**Agenda Item 3**  
**825 Morningside Drive**  
**Consideration of demolition of the existing residence and attached garage, a  
replacement residence and attached garage and the associated hardscape  
and landscape plan.**

## 825 Morningside Drive

**Property Owners: Richard and Amanda Small  
Architect: Diana Melichar**

**Agenda Item 4**  
**1080 Sir William Lane**  
**Consideration of a new single-family residence, attached garage and  
associated hardscape and landscape plan on a vacant lot.**

# SITE/GRADING PLAN PROPOSED

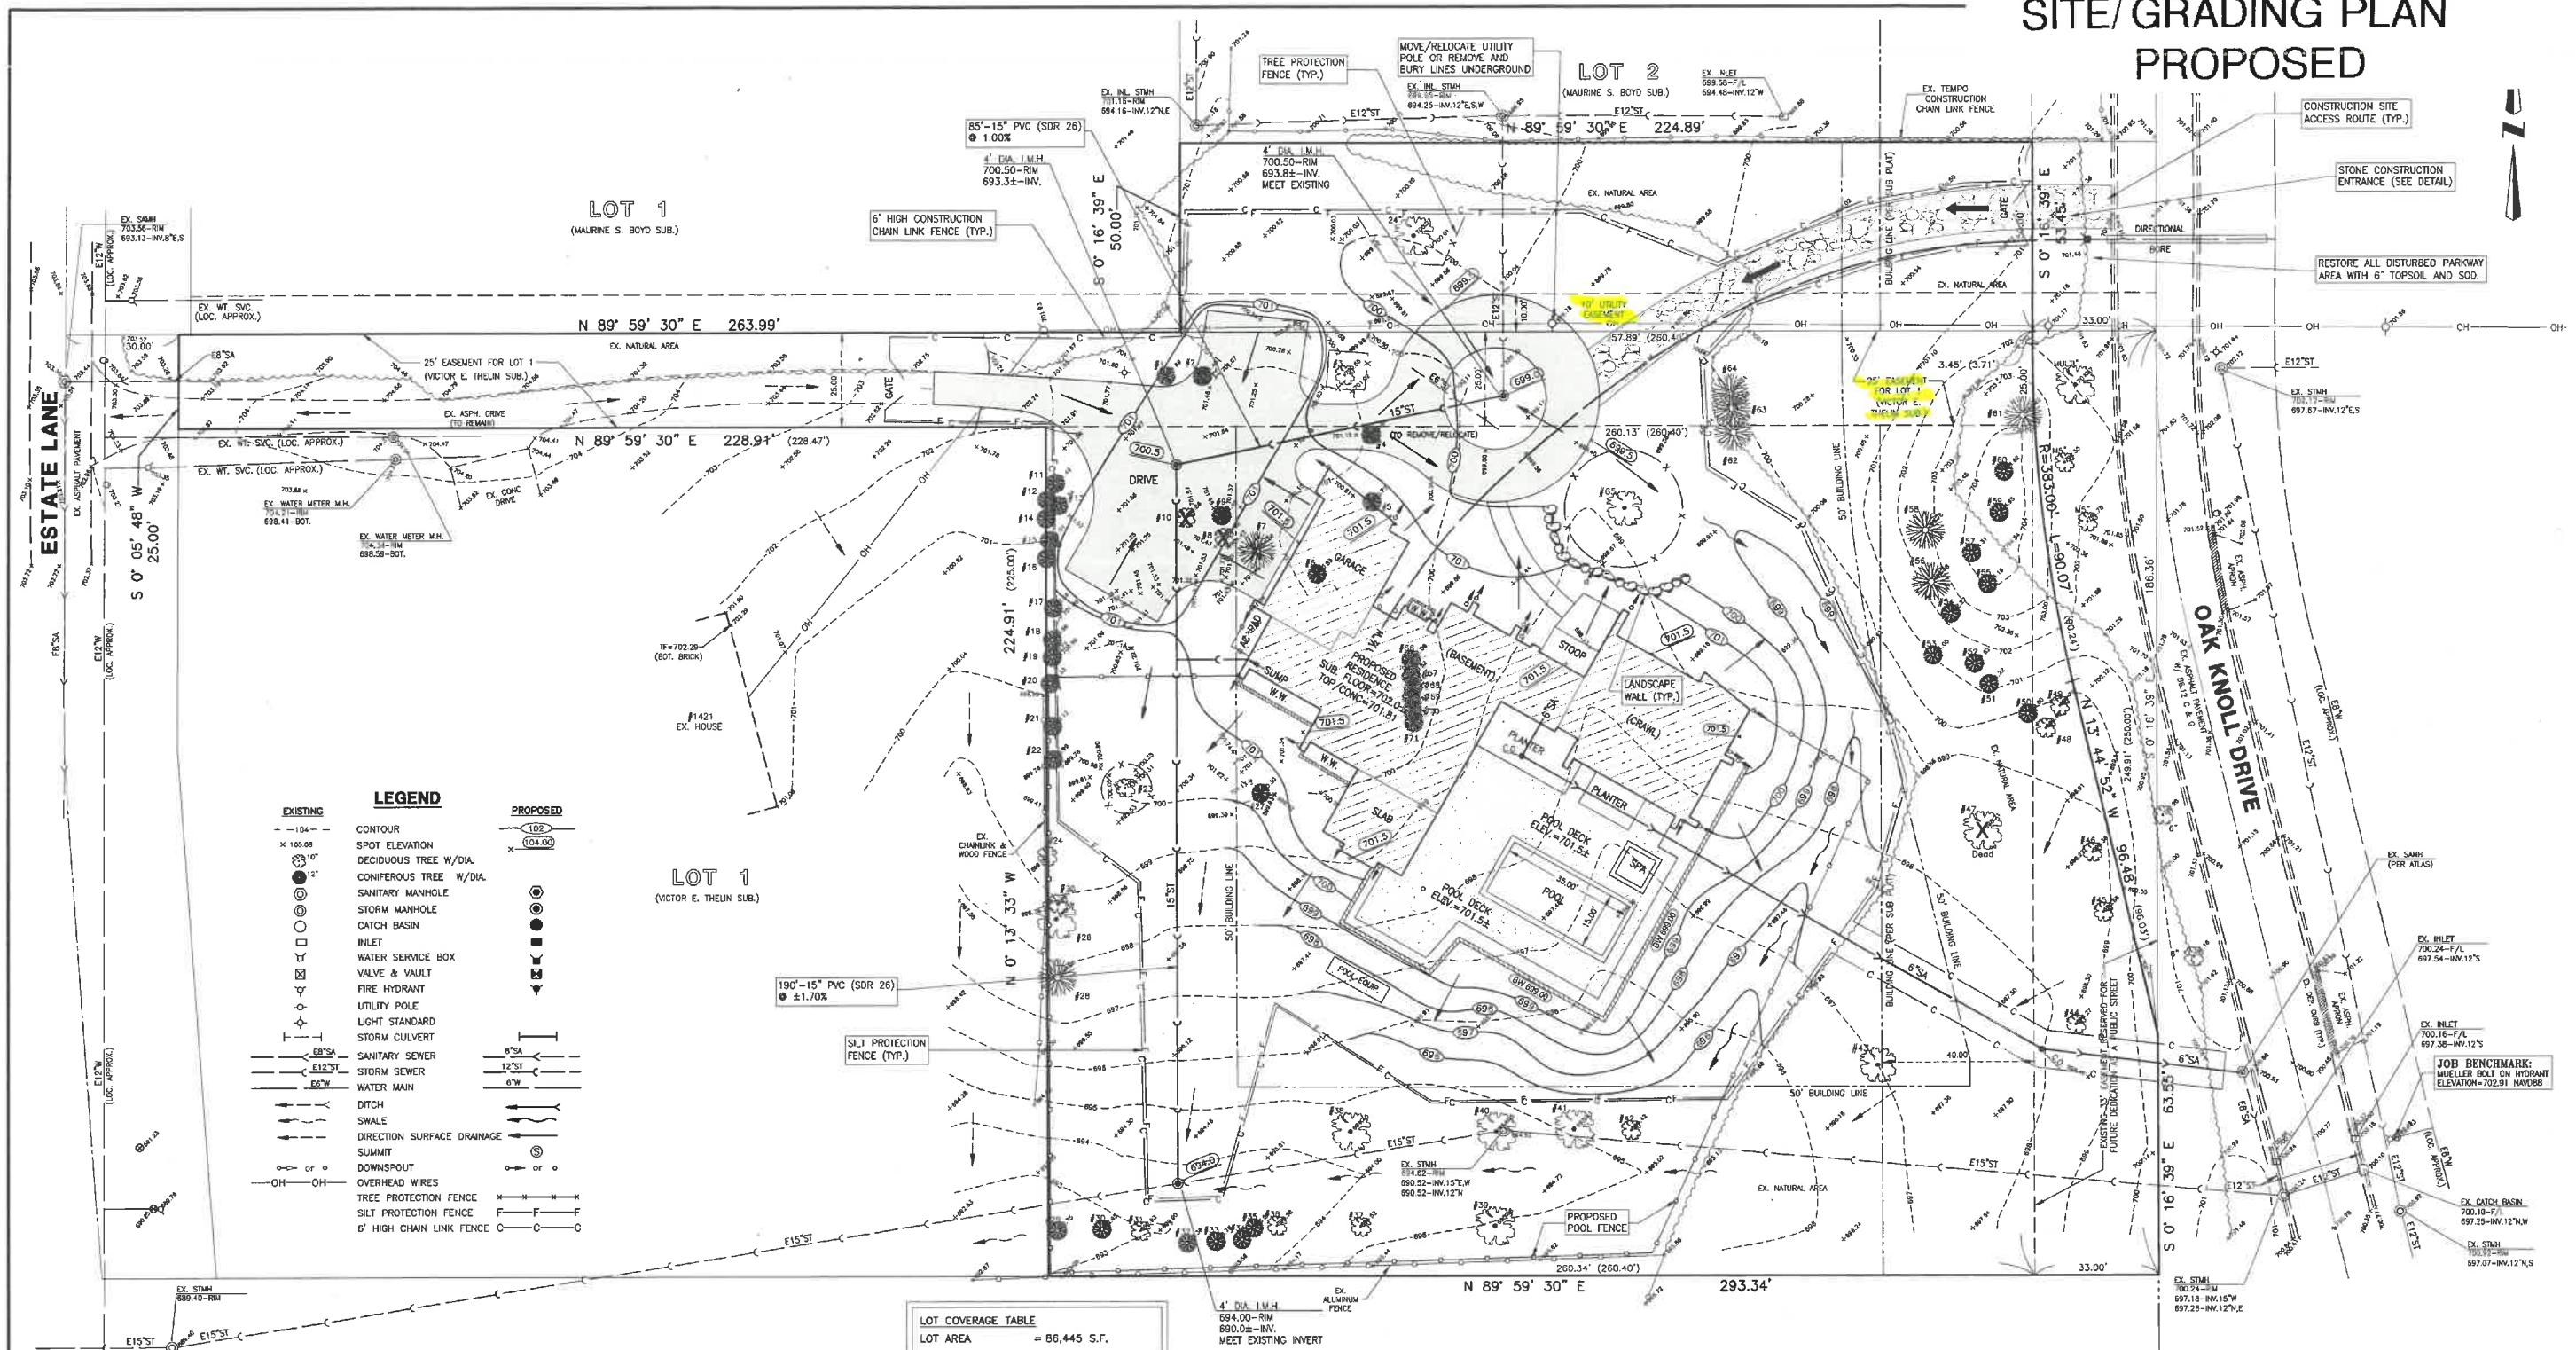
The grading plan proposes construction access from Oak Knoll Drive. The landscape plan demonstrates a plan to remediate the impact of the construction entrance. However, a construction entrance from Oak Knoll Drive is not permitted without a curb cut and a curb cut is not permitted unless a driveway is established.

**Recommendation:** Show the new storm sewer line and the 20' easement for the existing public storm sewer on the site plan. Include dimensions to reflect that all structures are at least 15' from the new storm sewer line.

1. Conduct further study and refinement of the site plan, elevations and materials.
  - a. Show the proposed relocated private storm sewer pipe and the 20' easement for the existing public (east/west) storm sewer on the plans. All structure must be setback at least 15 feet from the new storm sewer.
  - b. Submit documentation that the access easement through the subject property which benefits the 1421 Estate Lane property has been or will be vacated OR submit a revised site plan that reconfigures the driveway, roundabout and backout area to allow future access to Oak Knoll Drive for the 1421 Oak Knoll Drive property.
  - c. Consider refining the windows and sliding glass doors on all four elevations to create a more regular arrangement of openings and to better balance the solids walls and windows.
  - d. Bring samples of the exterior materials to the Board meeting.
